# SB-10056089-3867

Engine Control Unit Software Calibration Update  
Models: M.Y. 2014 Monster 1200; M.Y. 2014 Monster 1200 S (CAL/CDN versions)  
Technical Service Bulletin TSB-14-005

**SERVICE SOLUTION:**

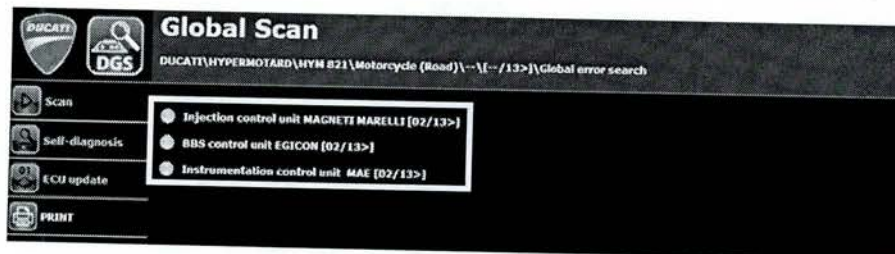
To update control units, proceed as follows:

- 1) Connect the DDS 2.0 tester to bike diagnostic socket.
- 2) Select the vehicle to be updated from the DDS 2.0 menu.
- 3) Execute the **Global Scan function** and wait for the scan result.
- 4) Check for available updates in column E:
  - YES – Available update
  - NO – No available update

- 5) Update all control units using the dedicated ECU update function, and follow the displayed instructions.
- 6) If updates are successfully accomplished a green symbol will appear.
